30011141-NGSF LTR 0002 ~ Rev 0

**Re: Newcastle Gas Storage Facility ISBL – Peer Review Services  
Summary Report to Period Ending 30 June 2014**

SMEC Australia (SMEC) has been engaged by AGL Energy Ltd (AGL) to undertake stormwater peer review services for design documentation and construction of the above project. These services are to satisfy a development condition for the project that was required by Hunter Water Corporation to ensure compliance with an agreed stormwater management philosophy for the works.

General photo showing installed slab reinforcement and waterstop

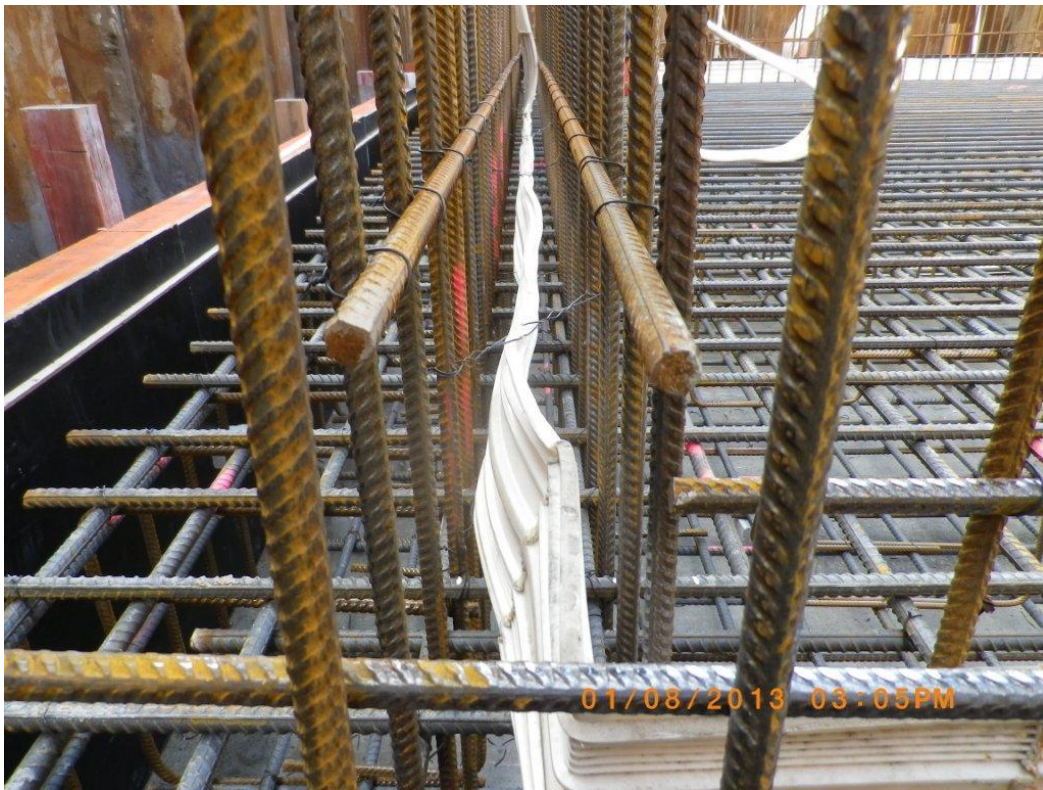
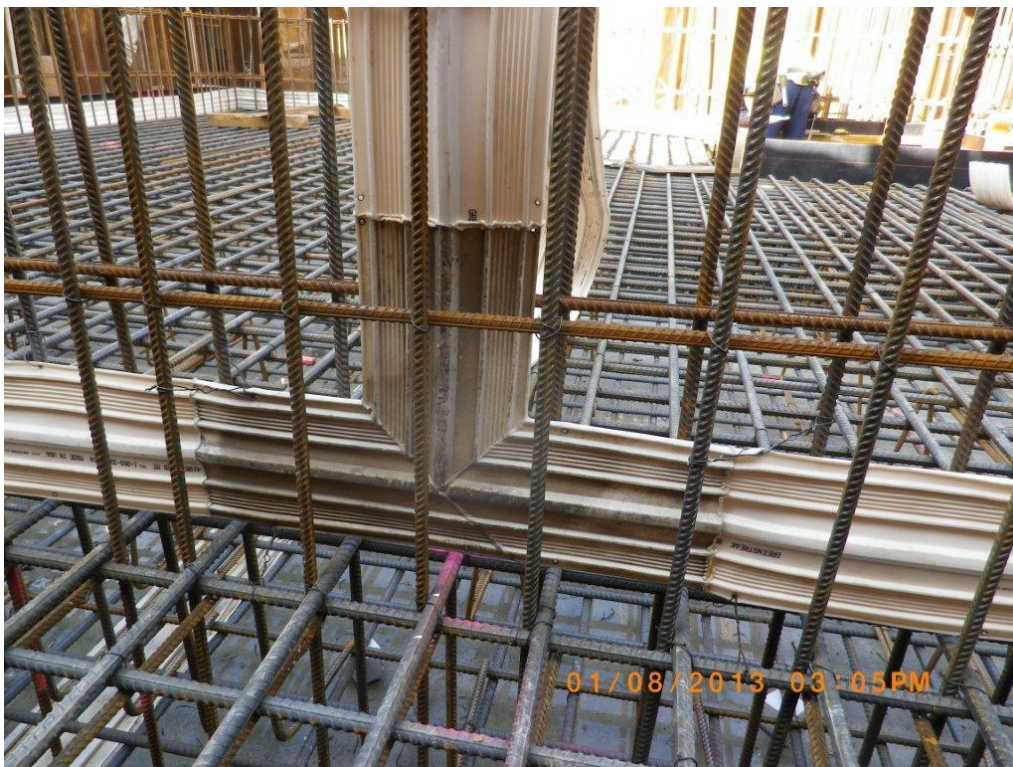
1. SMEC inspected the Tank Area LNG Impoundment Sump Base pour and found it to generally be in accordance with the approved Storm Water Management Philosophy for the site. This corresponds to ISBL Inspection 2. Layout of Bunded area for plant area.

2. Construction appeared to be of a standard that would allow the works to comply with the Approved Storm Water Management Philosophy. In particular SMEC noted water stops placed in position in accordance with the design drawings (refer to photos attached).

4. SMEC is satisfied with the standard of the works subject to the following:
  - a. Approval shall first be obtained from a qualified Structural Engineer prior to placement of concrete;

- b. Attention is paid to saw cuts to ensure they do not cut reinforcement and are sealed correctly
